LMVED-TD (NOD 20 Jul 73) 5th Ind
SUBJECT: Mississippi River-Gulf Outlet, Design Memorandum
No. 1 - General Design, Michoud Canal

DA, Lower Mississippi Valley Division, Corps of Engineers, Vicksburg,
Miss. 39180 8 May 74

LMNED-MP (20 Jul 73) 4th Ind 1 April 1974
SUBJECT: Mississippi River-Gulf Outlet, Design Memorandum No. 1,
General Design, Michoud Canal

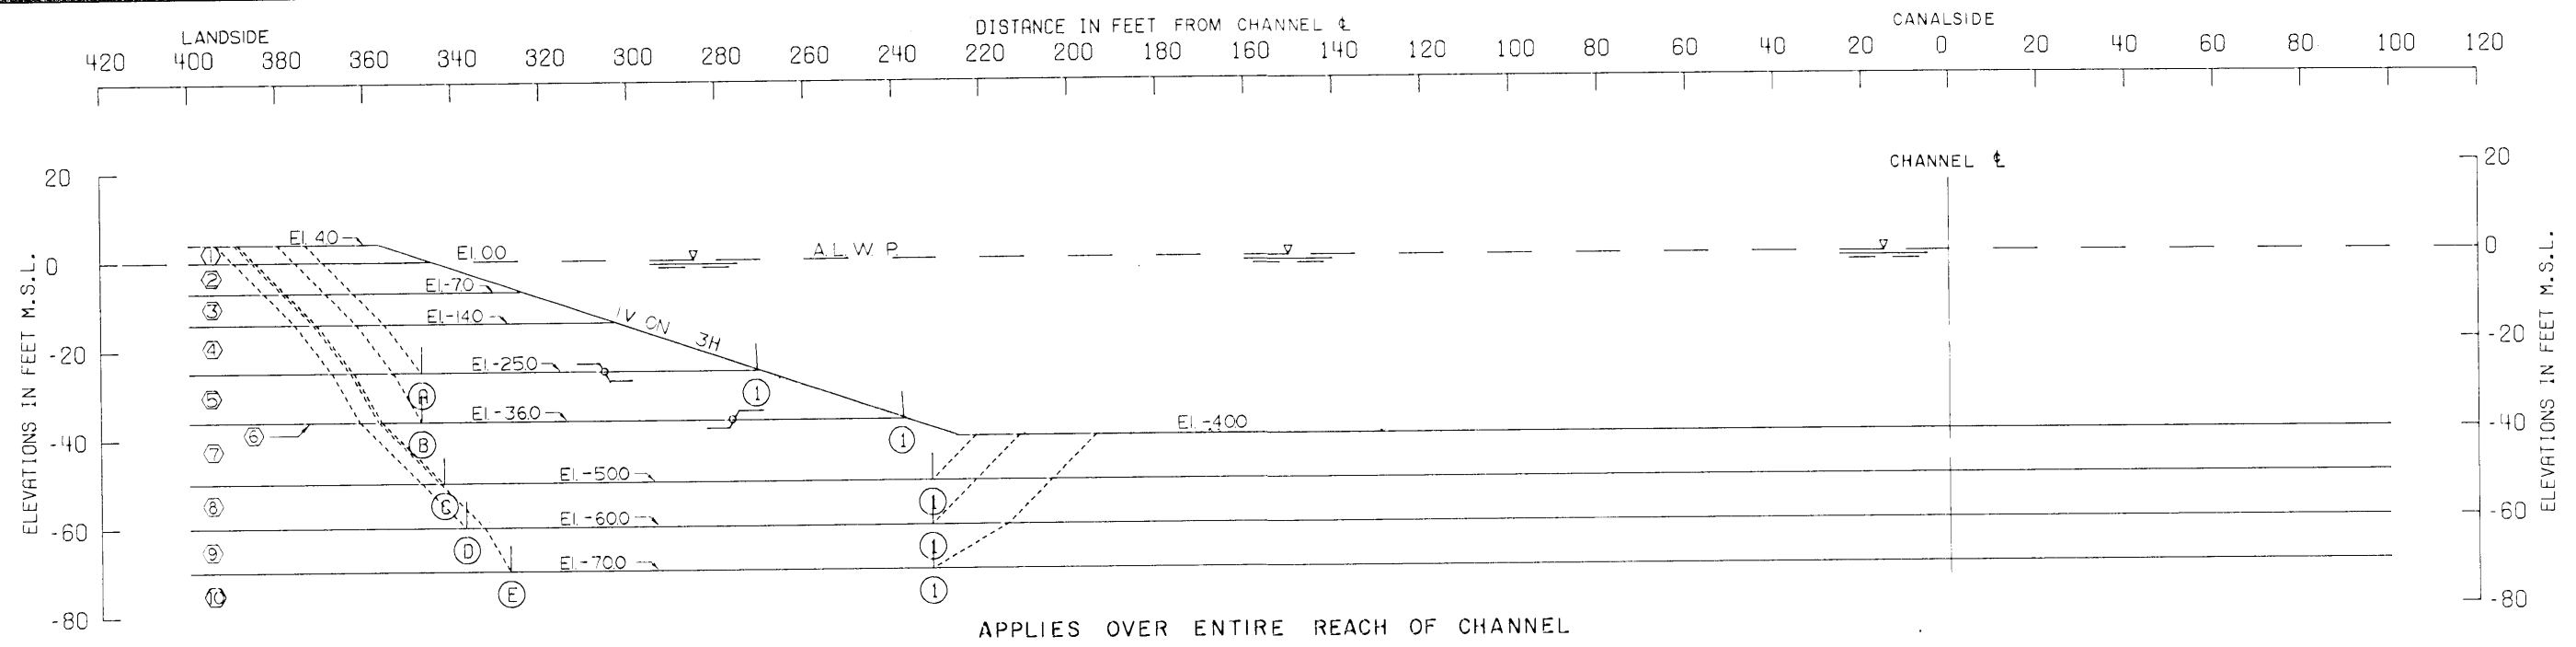
i. Plates 8 and 21. Boring 2-EUT on Plate 21 indicates clay CH, silt and silty sand between els. -22 to -32. The design shear strength of $\phi = 15^\circ$, $c = 200$ psf should have extended from el -14 to el -32. Use of this design shear strength between these depths will result in slightly lower factors of safety which may not reduce them to the extent of requiring a flatter slope. However, this should be investigated during preparation of plans and specifications.

10. Ref para i, 1st Ind. Plate 8 has been revised and is inclosed as inclosure 2. It is noted that the channel slope was not affected by the recommended change.

Channel stability analysis. The stability of the channel was analyzed using the following conservative assumptions: top of bank at elevation 4.0 m.s.l. and bottom of channel at elevation -40 m.l.g. with side slopes of 1V on 3H. The stratification and shear strengths were developed from boring 2-EUT (see plate 23 of GDM). The stability of the channel was analyzed by applying a minimum factor of safety with respect to shear strength of 1.3. This analysis is presented on revised plate 8, inclosed as inclosure 2.

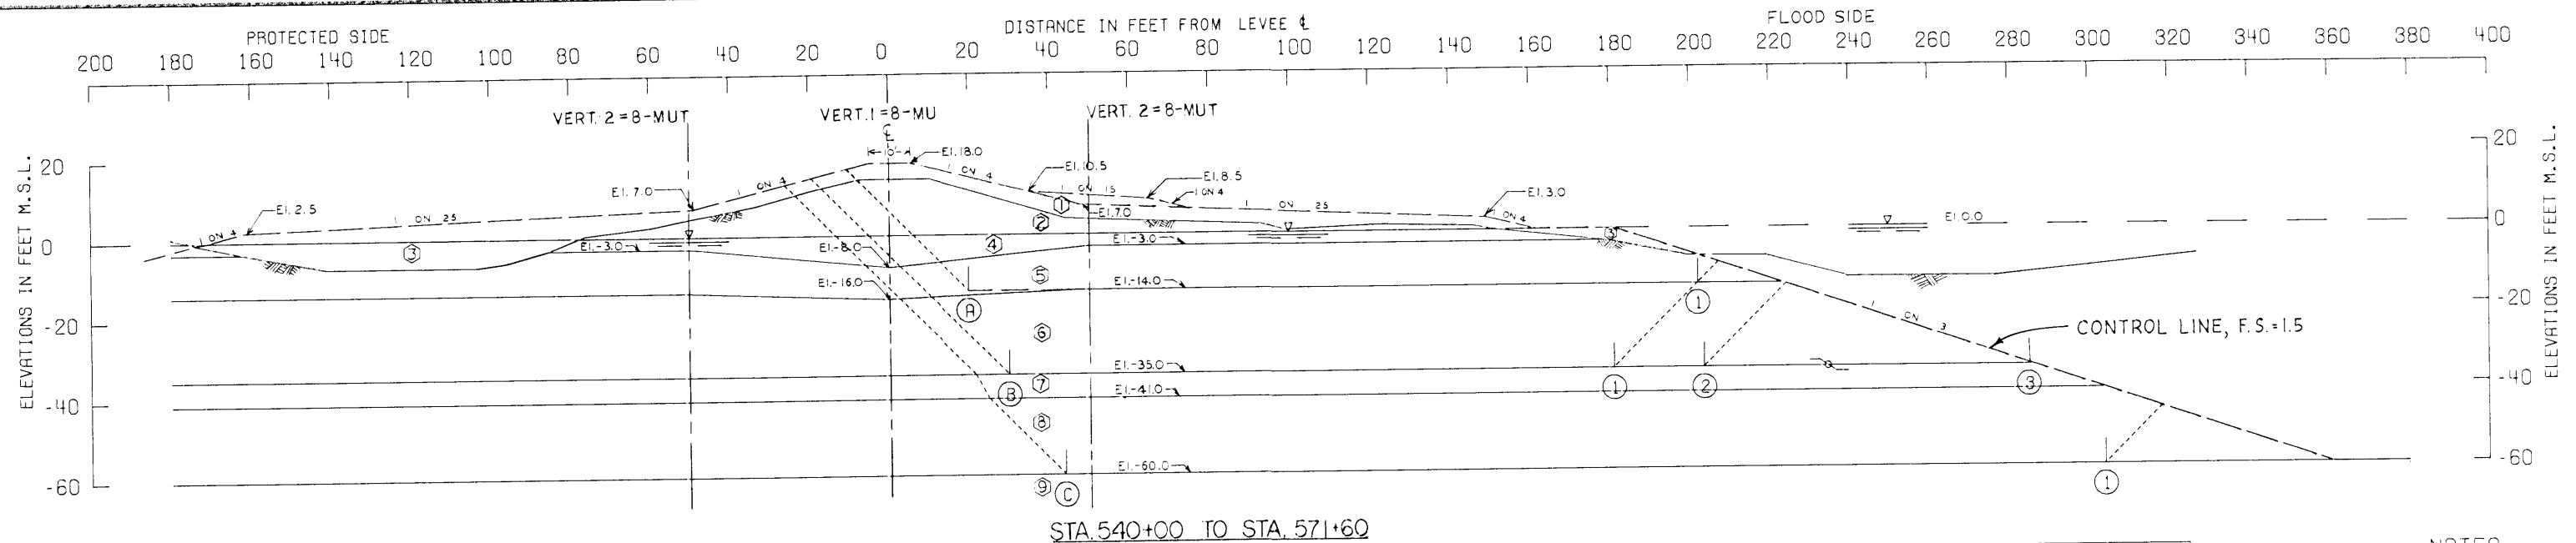
j. Plate 10. The factor of safety for assumed failure surface A-1 at el -14 is less than the 1.5 indicated for the stability control line. The stability control line should be adjusted so as to provide a factor of safety of 1.5 for this assumed failure surface.

11. Ref para j, 1st Ind. Plate 10 has been revised and is inclosed as inclosure 3. Note that there is a significant increase in underwater berm required.

APPLIES TO SPOIL AREA NO. 1, NO. 7, AND MAINTENANCE SPOIL AREA

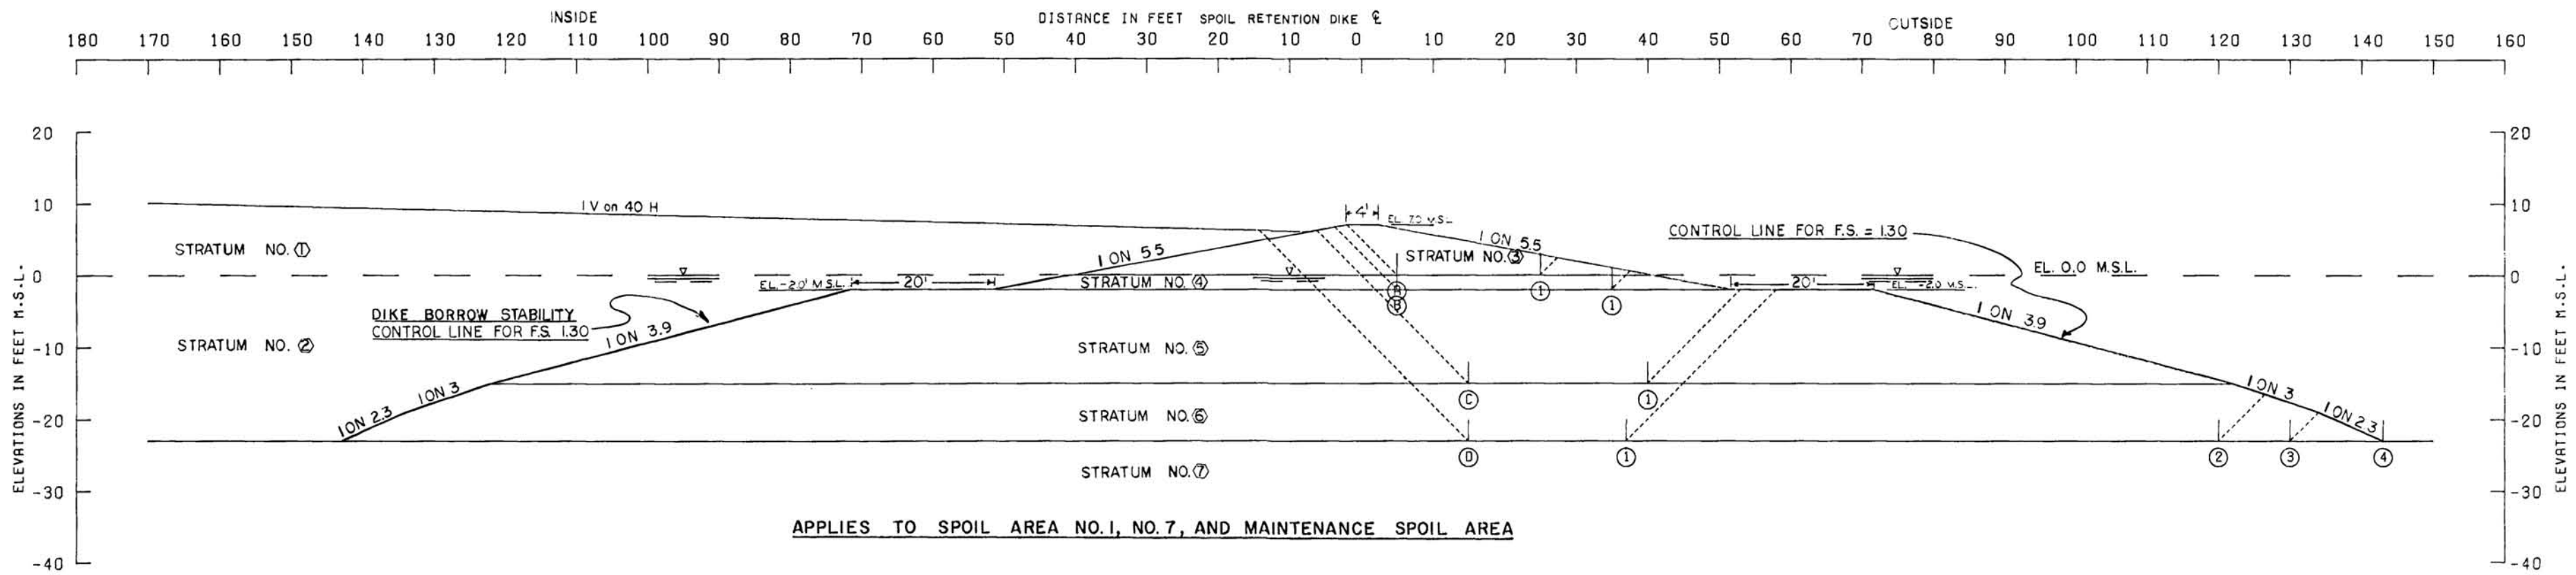
(1) The spoil dike stability analyses for spoil areas 1, 7, and the maintenance spoil area shown on Plate 16 are based on boring U-2 taken in this area in connection with DM No. 3 "Chalmette Area Plan, GDM." This is considered satisfactory if this boring accurately reflects the foundation conditions and strengths which will be encountered during the construction of these spoil dikes.

5. Ref para d, 1st Ind. Concur. Paragraphs 31c(1) and 31c(2) have been revised as noted below. Plates 16 and 17 have been revised and are inclosed as inclosures 9 and 10, respectively. The two borings used for the information presented on revised plates 16 and 17 represent the best available and are considered representative for their respective areas.

Spoil areas no. 1, 7, and maintenance spoil area. The dike stability for spoil areas no. 1, 7, and the maintenance spoil area was analyzed based on shear strengths and stratifications from boring U-2 taken in this area in connection with DM No. 3, "Chalmette Area Plan, GDM." The analysis was made for top of dike at elevation 7.0 m.s.l., side slopes 1V on 5.5H, spoil elevation varying from elevation 6.0 m.s.l. at the dike to a maximum spoil elevation of 10.0 m.s.l. with assumed failure to the outside of the spoil area and for a minimum factor of safety of 1.3. Practically all of the dikes in spoil area 1 are existing and will be used or rebuilt where necessary. Approximately one-half of the necessary dikes for spoil area 7 now exist with the remaining dikes to be constructed. No dikes exist in the maintenance spoil area and new dikes will be constructed. The stability analysis pertinent to the new dike construction for these areas is shown on revised plate 16, incl 9.
